MC68HC05F5

Addendum to
MC68HC05F5
HCMOS Microcontroller Unit
Technical Data

This addendum adds information to *MC68HC05F5 Technical Data* (Motorola document number MC68HC05F5/D) as follows:

Page 1-3, **Figure 1-1. MC68HC05F5 Block Diagram**, correct as follows:

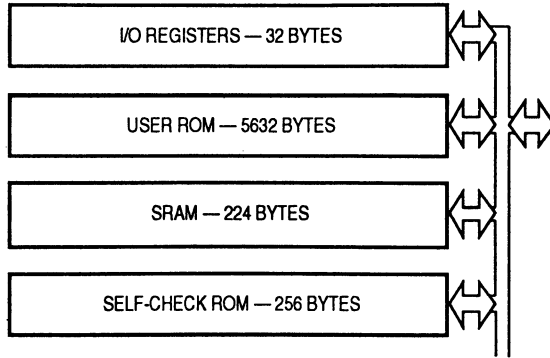
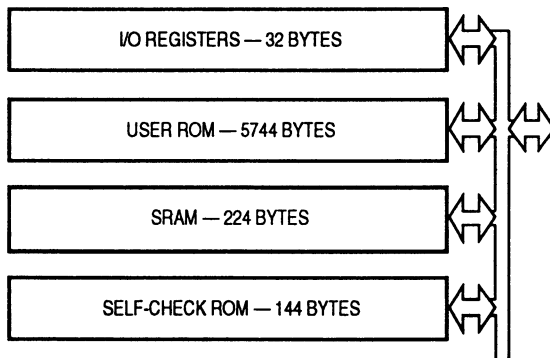
From:

To:

Page 12-5, **Figure 12-5. Maximum Supply Current vs Clock Frequency**, correct as follows:

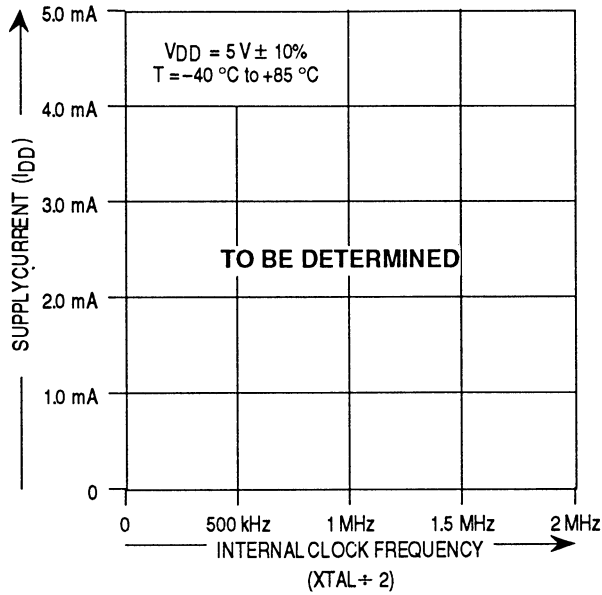
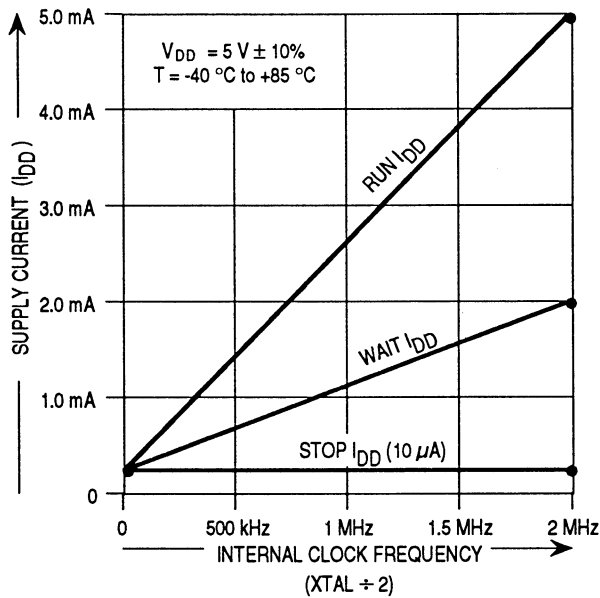
From:

To:

Page 12-7, **Figure 12-7. DTMF Receiver Timing**, correct as follows:

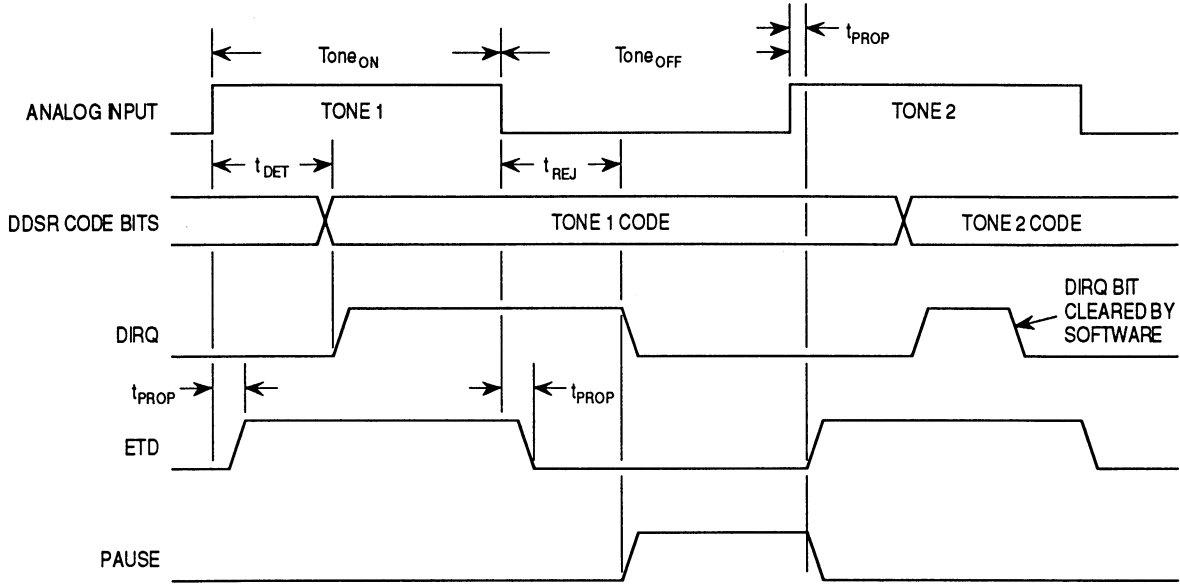
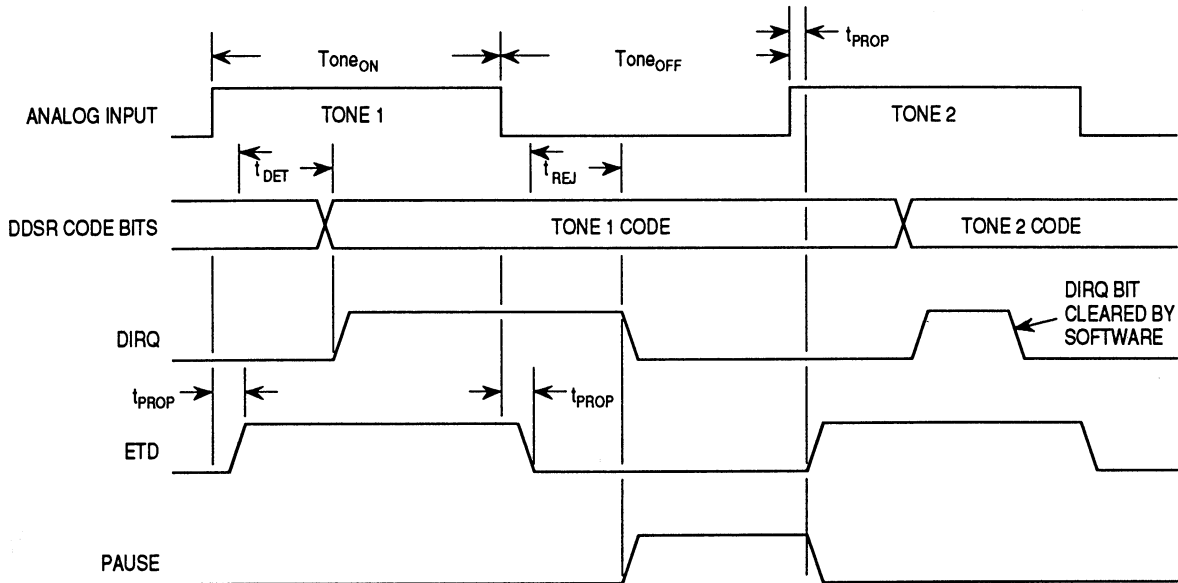
From:

To:
